SERVICE BULLETIN (MANDATORY) N.: SB-80-0262 REV.3 ATA CHAPTER: 55-20

MODIFICATION N.: DMT 80-0866 and DMT 80-1021

TITLE: P180 - HORIZONTAL STABILIZER TO ELEVATOR HINGE FITTING - INSPECTION AND MODIFICATION

Rev. N. **3** Date: **November 14, 2011**

Figure. 3 – Example of wrong holes on Horizontal Stabilizer rear spar

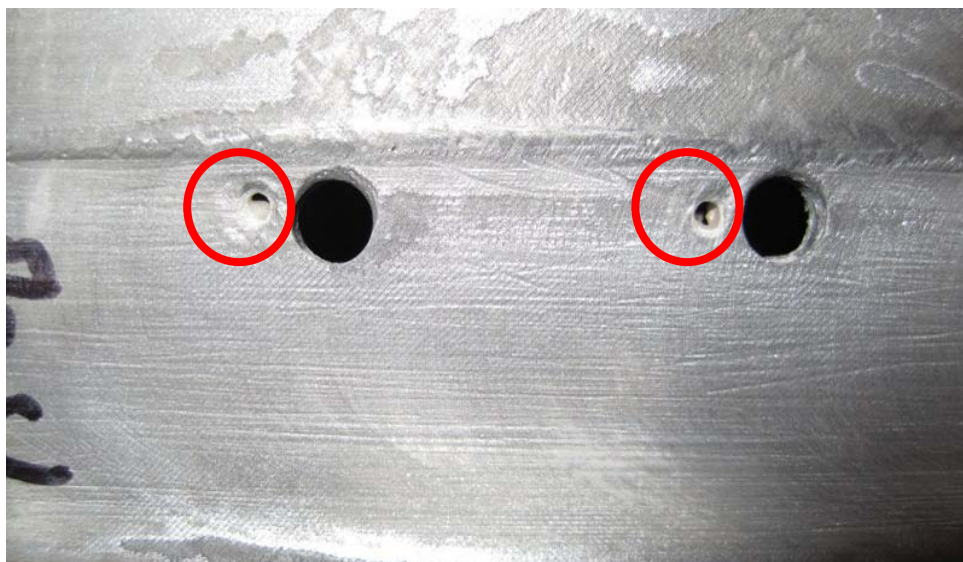
- 7 Visually inspect the rear spar area in correspondence with the fittings
- 8 If, following inspection as per previous point, pilot holes are detected (refer to figure 3):

8a Identify type of defect:

TYPE I: full size holes drilled adjacent to the correct ones, that form an 8-shape

TYPE II: 2.5 mm pilot holes that are drilled in the wrong position (see also figure 3)

- 8d Only for defect TYPE II, verify that the position of the defects is within 3D from the main holes (D is the diameter of the main holes) . Nominal value of D=.199 - .202 in.

- 8e If the defect is as TYPE I or TYPE II and (for TYPE II only) complies with the previous step 8d, no repair is needed except the cleaning of the defects.

- 8f Take a picture of the holes, measure their dimension (diameter) and position. Fill in the Failure report form as per latest issue of Service Letter 80-0097 latest revision.

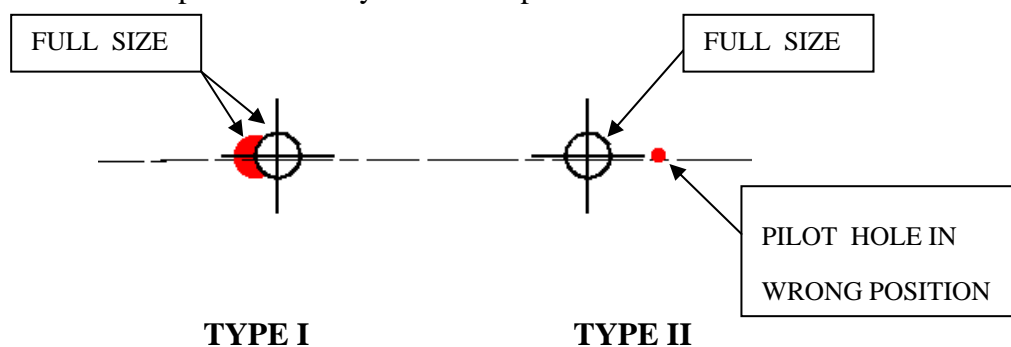
NOTE: The pilot holes may be found open or covered with conductive sealant

- 8b If defect (TYPE I or TYPE II) is covered clean it from any residual of sealant and other debris
- 8c Verify there are no other defects around holes in the rear spar flanges (upper and lower flange)

Figure 5

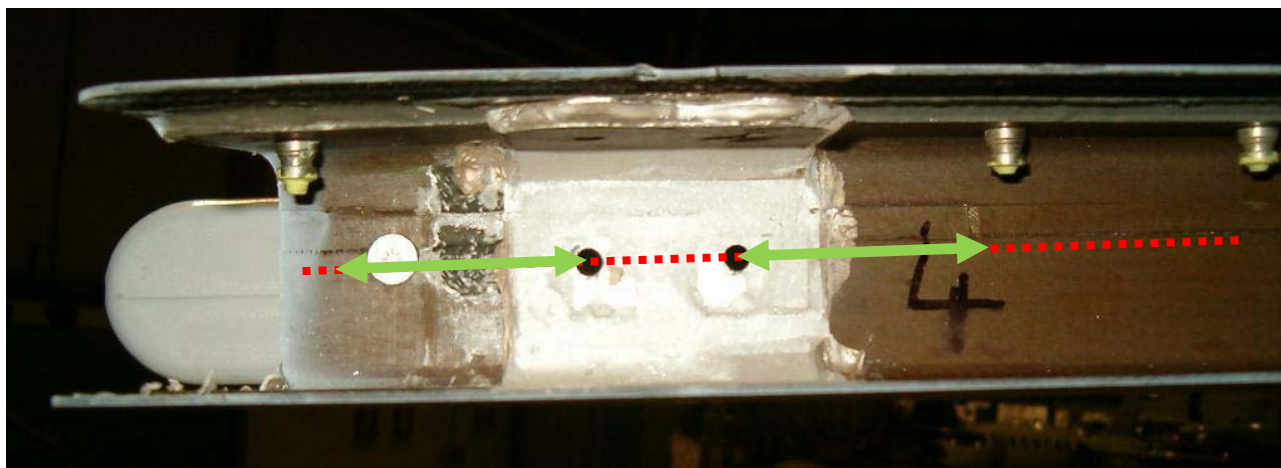
- Using a pen, track a reference line passing through the holes on the rear spar of the Horizontal Stabilizer, in correspondence with the two rear fastener of each fitting (refer to the red dotted line in figure 5). Install a “paper adhesive tape” on the Horizontal Stabilizer to track a line on it (not in the picture).

- Temporary install the old fittings on the horizontal stabilizer. Use temporary fasteners on the upper and lower fitting faces only.
- Mark 2 points, located on the reference line tracked before, 5 cm from each of the 2 fastener position on the rear side of the fitting (refer to the green arrows in figure 5).
- Remove the old fittings
- Temporary install the new fittings on the horizontal stabilizer. Use temporary fasteners on the upper and lower fitting faces only.
- Using a pen, mark the 2 fastener positions on the rear side of the new fittings: they are 5 cm from the points previously marked on the reference line.
- Remove the new fittings
- Drill pilot holes (2.5 mm).
- Temporary install the new fittings at the proper locations and check the correspondence of the pilot holes with Horizontal Stabilizer holes on the rear spar,

- Remove the new fittings
- Drill the finite holes (see fig.7-8-9-10) taking into account the offset of the pilot hole.
- Apply Alodine at the new fitting holes
- Remove the “paper adhesive tape”.

Fig.8 – Center Fitting lateral view (common for LH and RH).

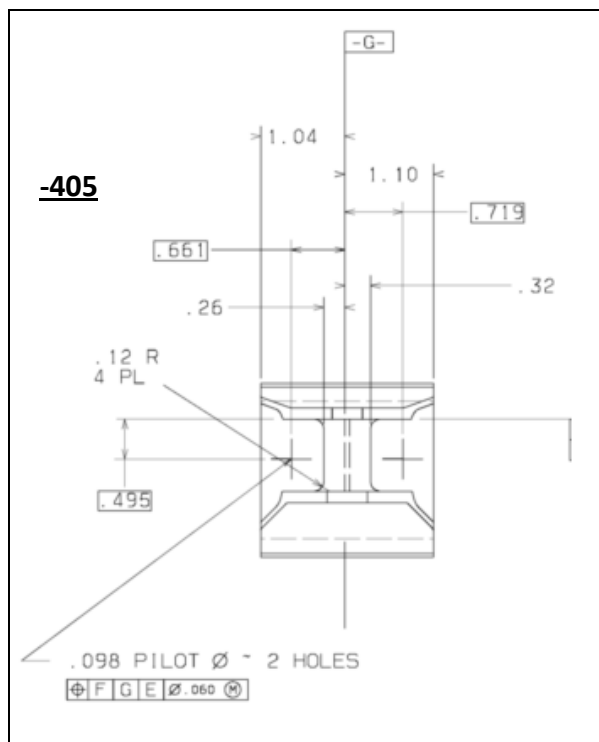
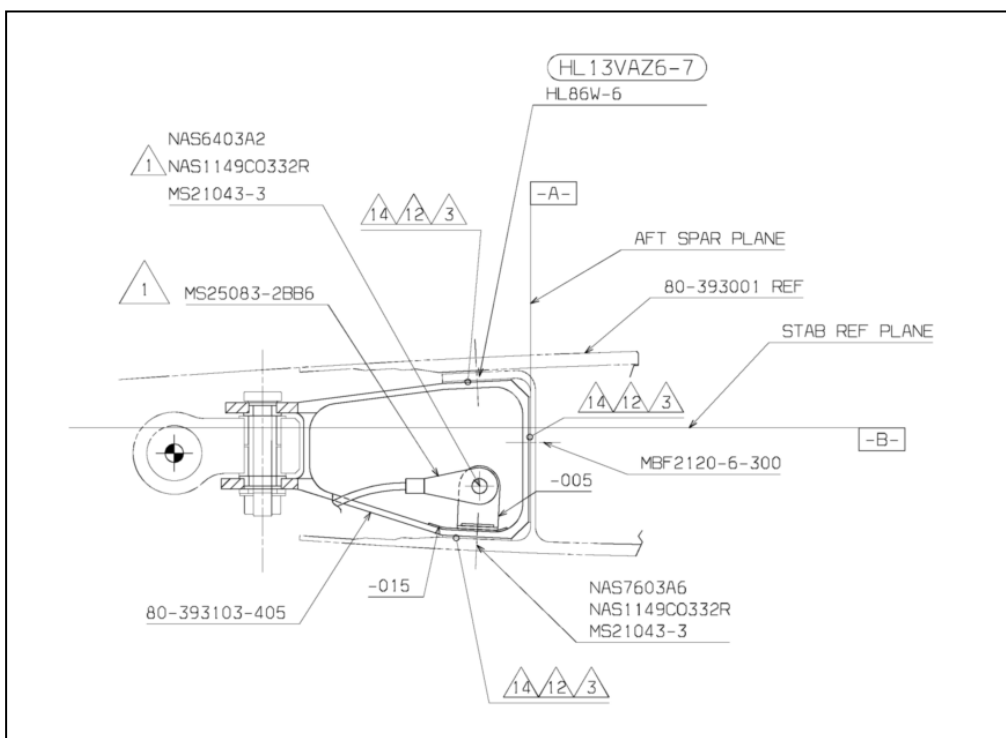
- 13 Using stainless steel brush, remove the conductive adhesive KS4008 located at the hinge fitting zones on the horizontal stabilizer carbon skin
- 14 Apply the EA956A/EA956B resin on the fiber glass pad, using the nylon film envelope as detaching layer. Cut two rectangular patches (55mm x 105mm) for the external fitting and (55mm x 115mm) for the center one, and attach them on the fittings external surfaces (see fig. 6). Apply an appropriate pressure for the dry time (12h-18h).
- 15 Install the center fitting P/N 80-393103-405 using temporary fasteners and the epoxy adhesive (EA 934 NA) as sealant (ref also to fig.7-fig.8).

- 16 Install the permanent fasteners on the center fitting as per SRM 51-41-00 (ref also to fig.7-fig.8)
- 17 Install outboard fitting P/N 80-393103-407 using temporary fasteners and the epoxy adhesive (EA 934 NA) as sealant (ref also to fig.9-fig.10).

Fig.9 – Outboard Fitting lateral view (common for LH and RH).

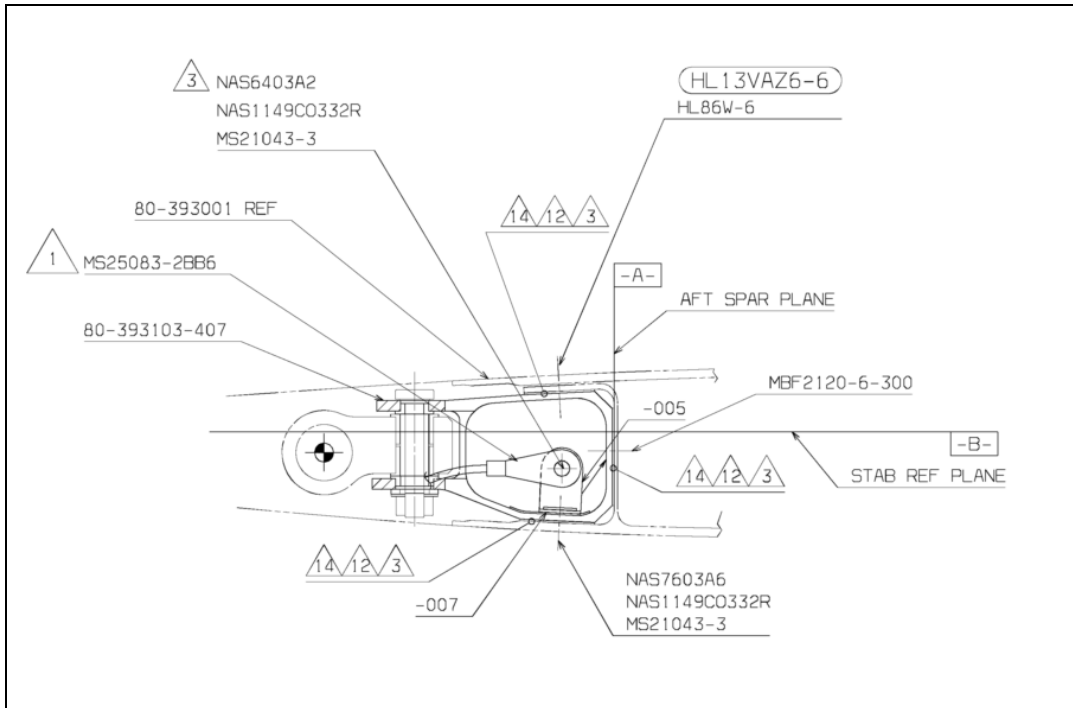
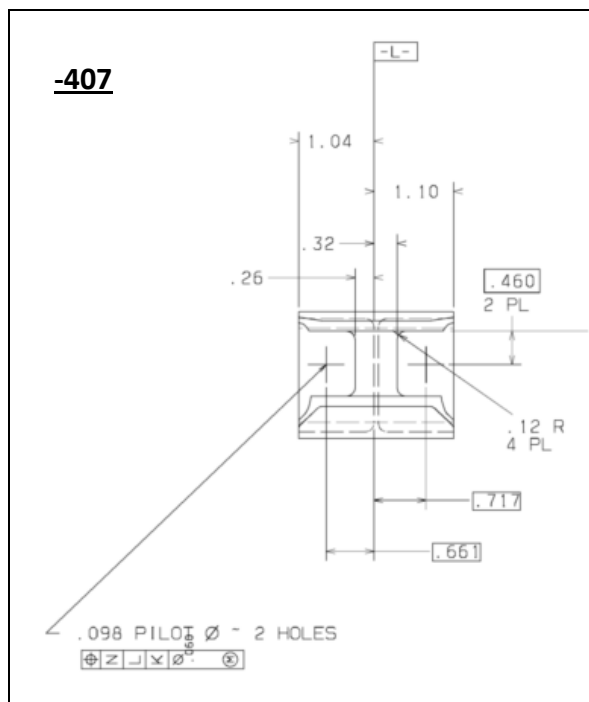
- 18 Install the permanent fasteners on the outboard fitting as per SRM 51-41-00 (ref also to fig.9-fig.10)

Fig.11 – Electrical Bonding strip upper view (common for LH and RH).

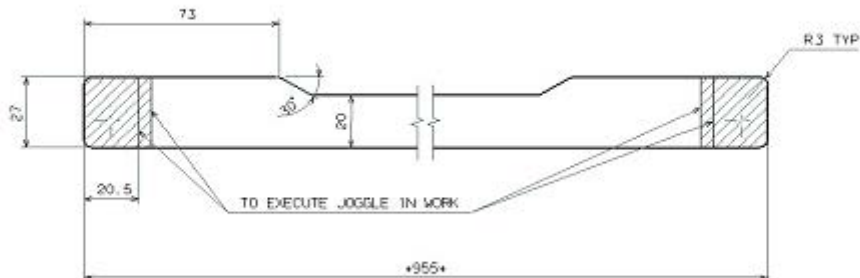
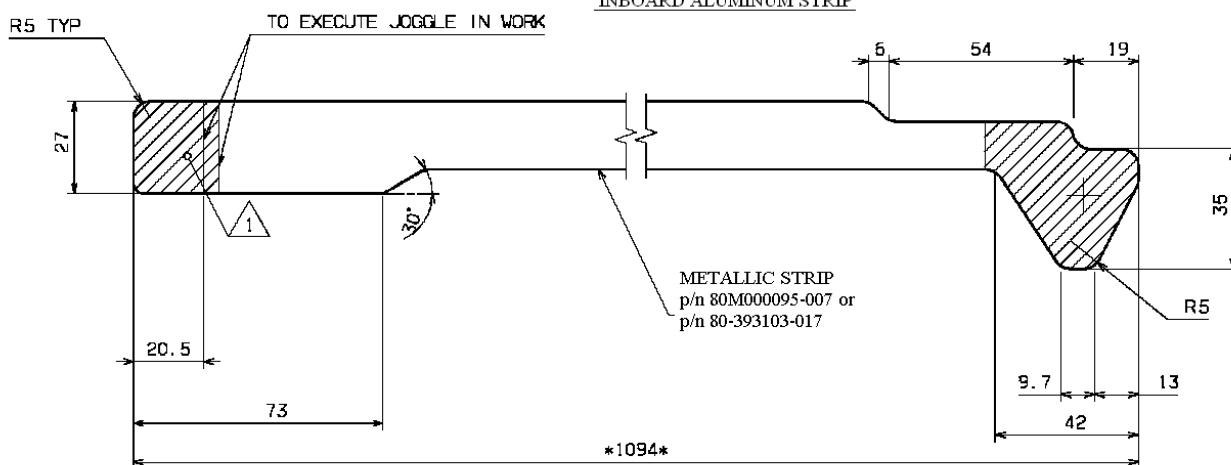
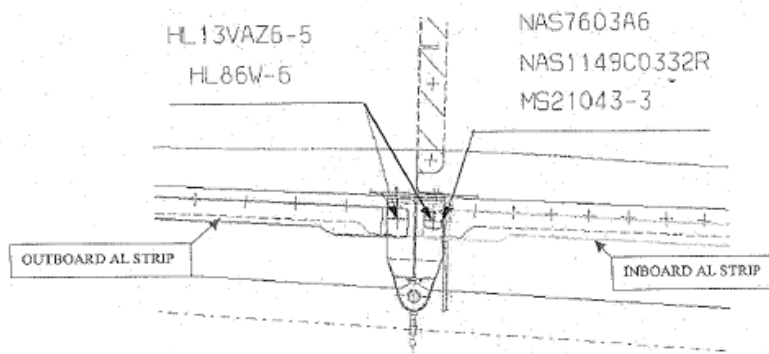
WITH REFERENCE TO FIG.11, REMOVE ANY GREASE, OIL AND PAINT FROM THE DASHED AREA OF THE ALUMINUM STRIP LOWER SURFACE, TO ASSURE PROPER BONDING

- 19 Recover the electrical bonding by applying the aluminum strips. Refer to fig. 11 and to SRM, ATA 51-70-80, Chapter 6 (*Repair Procedure for the Horizontal Stabilizer Hinge Corrosion*), Section B (*Repair*), paragraph 4 (*Aluminum Strip Installation*).

- 22 With reference to fig. 11, apply an ALODINE 1200 protection coat on the dashed area of the aluminum strip - upper surface (Ref. AMM 51-23-00).
- 23 Verify the electrical conductivity by connecting a standard milliohmeter probe at the central end external hinge fitting and at a convenient ground point of the battery. If the resistance value is 20 milliohms or less, the electrical bond is acceptable otherwise inspect the aluminum strips installation. Contact Piaggio Aero Technical Support if additional support is required.

Fig. 12– Detail of inboard strip installation

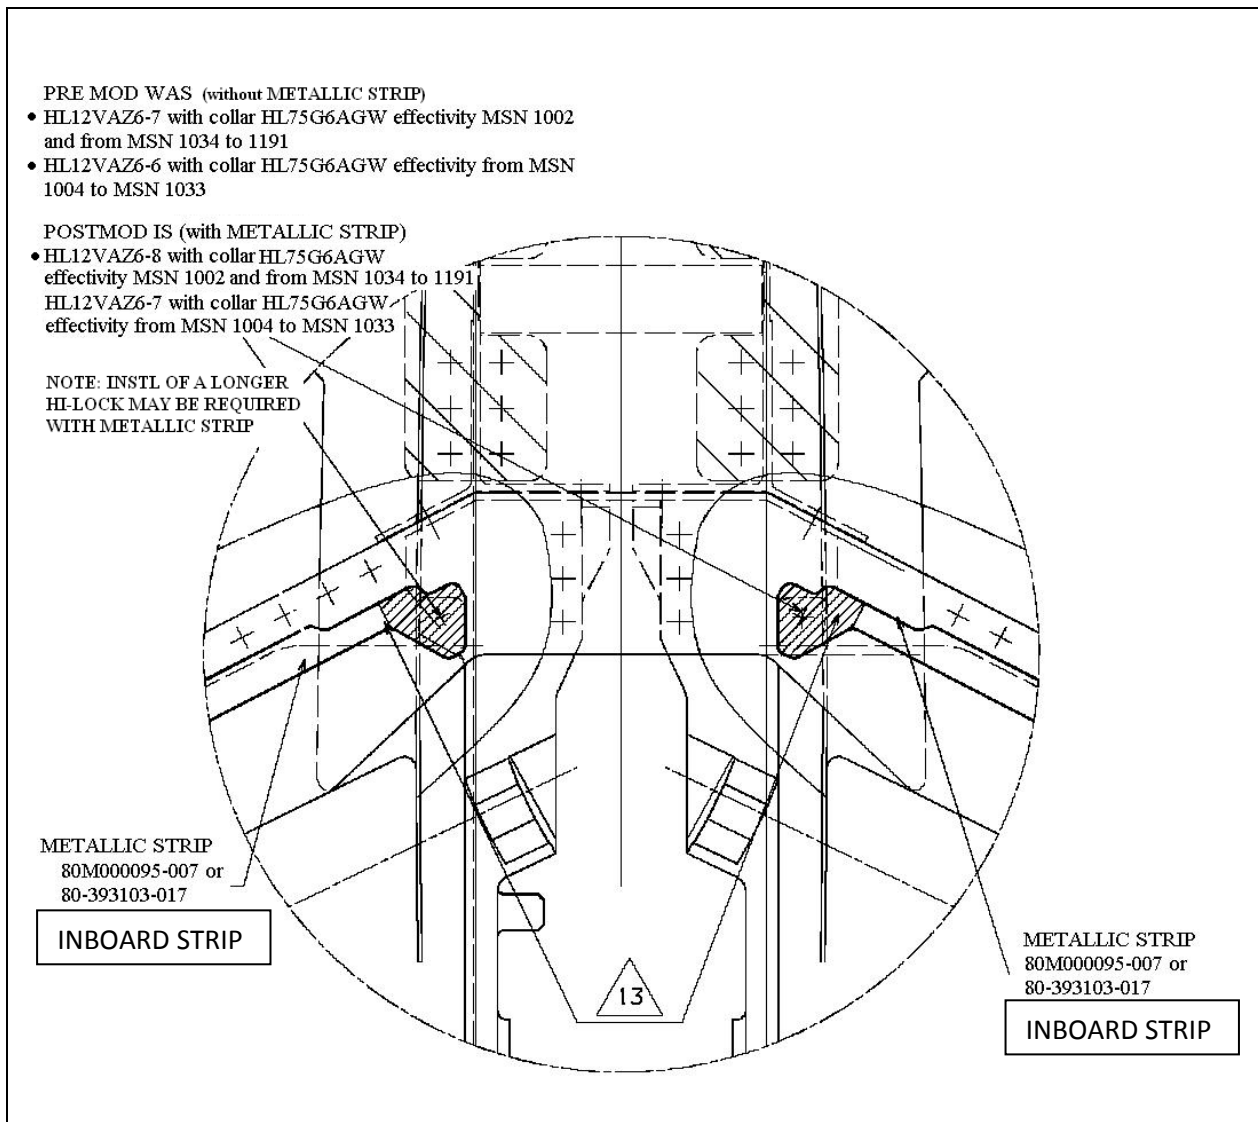
- 20 With reference to fig. 12:
- a. (effectivity MSN 1002 and from MSN 1034 to MSN 1191) remove the Hi-Lock p/n HL12VAZ-6-7 with relevant collar
 - b. (effectivity from MSN 1004 to MSN 1033 - horizontal stabilizer manufactured by Sikorsky) remove the Hi-Lock p/n HL12VAZ-6-6 with relevant collar

- c. (effectivity: all) remove the self-locking nut p/n MS21060-3 located at the inboard end of the horizontal stabilizer LH trailing edge lower skin (Ref. AMM, ATA 51-43-00).

- 21 With reference to fig. 12:
- a. (effectivity MSN 1002 and from MSN 1034 to MSN 1191) install a new Hi-Lock p/n HL12VAZ-6-8, plus collar p/n HL75G6AGW on the aluminum strip in lieu of the Hi-Lock previously removed

- b. (effectivity from MSN 1004 to MSN 1033 - horizontal stabilizer manufactured by Sikorsky) install a new Hi-Lock p/n HL12VAZ-6-7, plus collar p/n HL75G6AGW on the aluminum strip in lieu of the Hi-Lock previously removed

- c. (effectivity: all) reinstall on the aluminum strip the Self-Locking Nut previously removed, using no. 2 rivets p/n NASM20605R3W8 (Ref. AMM, ATA 51-41-00).

INSTALLATION OF A LONGER HI-LOCK (HL12VAZ-6-9 EFFECTIVITY MSN 1002 AND FROM MSN 1034 TO MSN 1191; HL12VAZ-6-8 FROM MSN 1004 TO MSN 1033) MAY BE REQUIRED IF ALUMINUM STRIP P/N 80-393103-017 (OR P/N 80M000095-007) IS INSTALLED.
